### SUNDRY NOTICES AND REPORTS ON WELLS

8 Well Name and No  
SKELLY UNIT #965    (29742)

9 API Well No  
30-015-34647

**Skelly Unit #965**  
**Chevron / COG Operating LLC**  
**30-015-34647**  
**June 22, 2011**  
**Conditions of Approval**

#### **12. Summary Drilling and Completion Program**

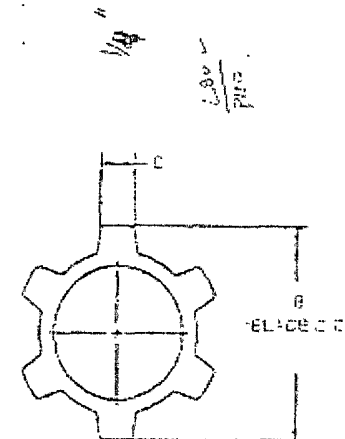
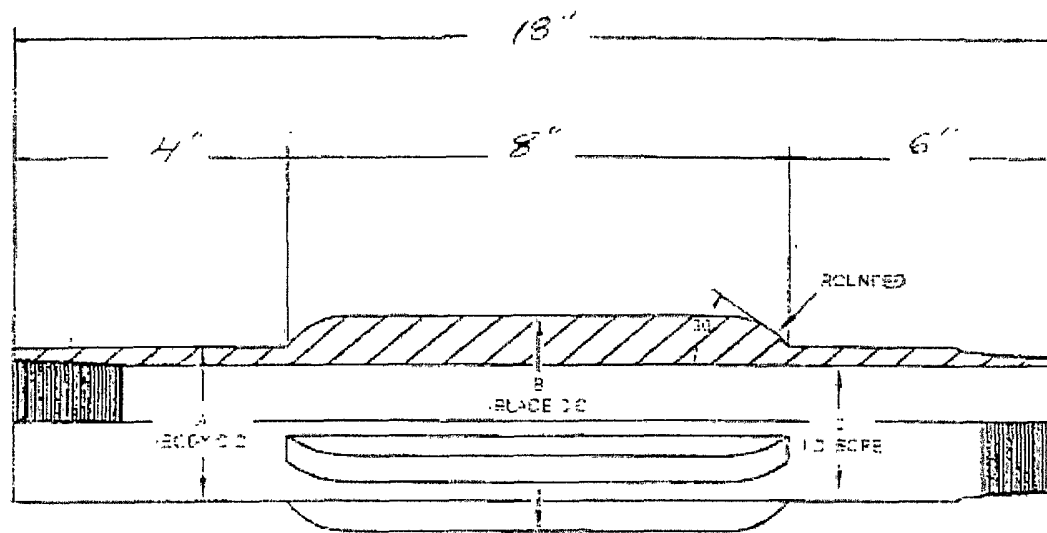
- f) The planned depth for setting the DV tool should be revised to  $\pm 4907'$ , or shallower; which is above the top of the open perforations to be squeezed. By doing so, all of the squeezed perforations will be cemented behind the 4" casing. When plugged, a cement plug will be required across this tieback.

- g) The proposed centralizer locations for the shoe, the perforated intervals, and the liner top are acceptable, and will provide necessary centralization in the liner lap, without a liner hanger.

- h) The 4" casing will be backed off above the DV tool, now being located at  $\pm 4907'$ .
- i) If cement does not circulate from the DV tool, the appropriate BLM office is to be notified. In that event, Operator to recommend the alternate method of confirming TOC.
